Applicant : Lawrence D. Knox, et al.  
Serial No. : 10/629,243  
Filed : July 28, 2003  
Page : 15 of 26

Attorney's Docket No.: 02103-377003 / AABOSS14-  
CPCP

Amendments to the Drawings:

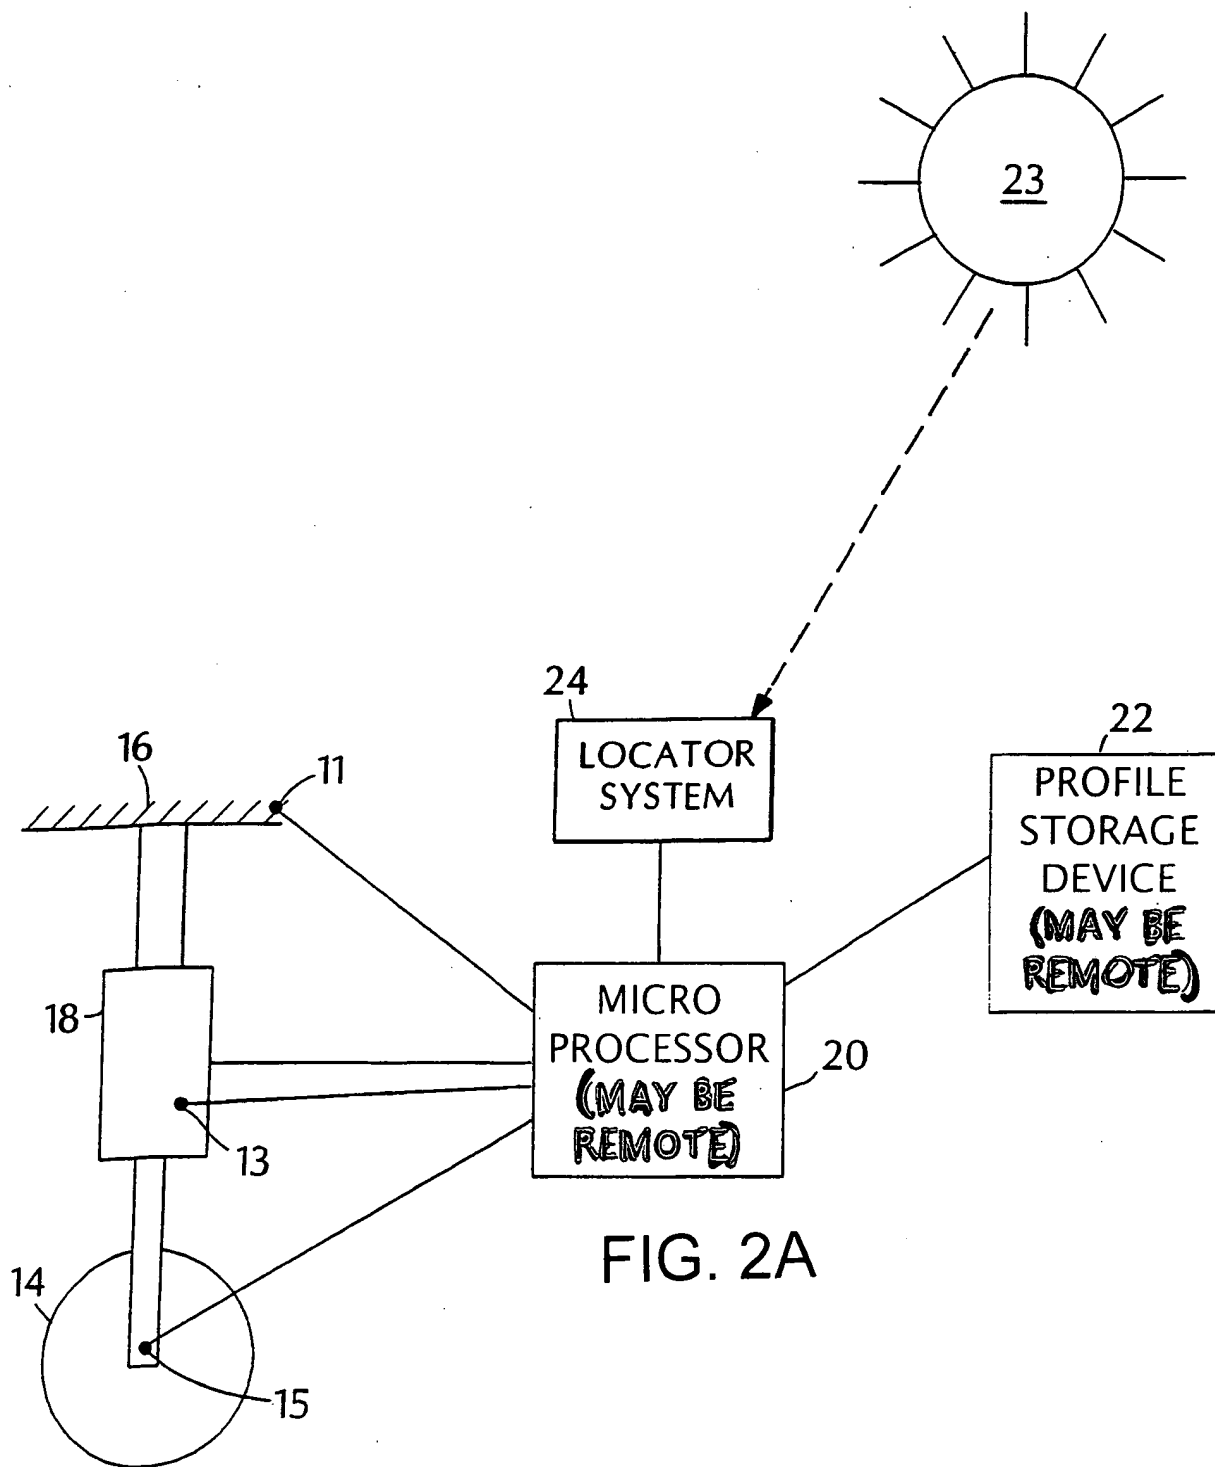
In Figure 2a, please insert "(MAY BE REMOTE)" in blocks 22 and 20.

**6. The drawings are objected to under 37 CFR 1.83(a). The drawings must show every feature of the invention specified in the claims. Therefore, the profile storage device and microprocessor remote from the surface vehicle (claims 2-3 and 21-22) must be shown or the feature(s) canceled from the claim(s). No new matter should be entered.**

(6.) Fig. 2a has been amended. At page 9, lines 21 – 28, it is indicated that the functions performed by microprocessor 20 may be performed by a number of microprocessors or

equivalent devices, some of which may be located remotely from vehicle 10 and that profile storage device 22 may be at some remote location.

FIG. 6A

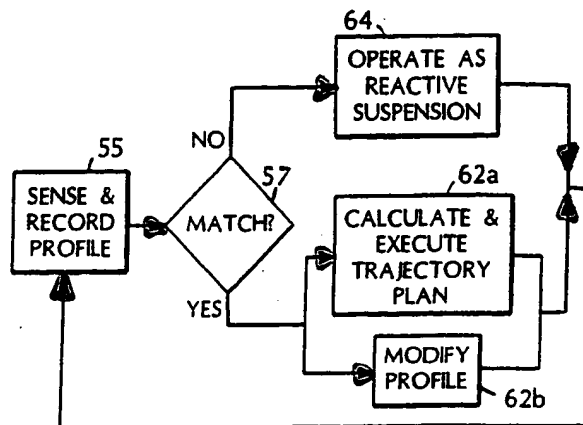
In Fig. 6a, please change "57" to "157".

**g. Figures 6a-6c are unclear because there are no arrows on the lines showing the direction of flow.**

**h. Contrary to page 15, lines 8-16 reference numeral 58 is not in Figure 6a (possibly, this should be reference numeral 57).**

(5g.) Figs. 6a – 6c have been amended to include arrows indicating the direction of process flow, consistent with the description of the process flow in the corresponding portion of the Specification.

(5h.) Reference numeral 57 in Fig. 6a and “58” at page line 9 have been replaced with “157”. The element indicated by reference numeral 157 in the Fig. 6a and the description of element 157 in the Specification are consistent.

FIG. 6B

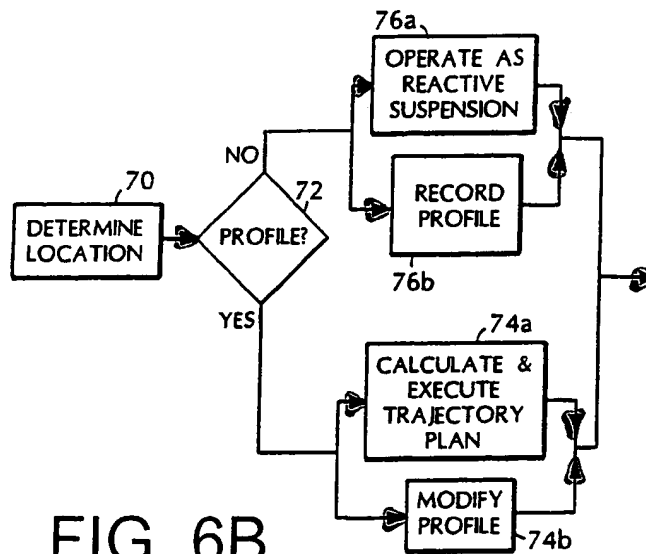
In Figs. 6a, 6b, and 6c, please insert arrow heads as indicated.
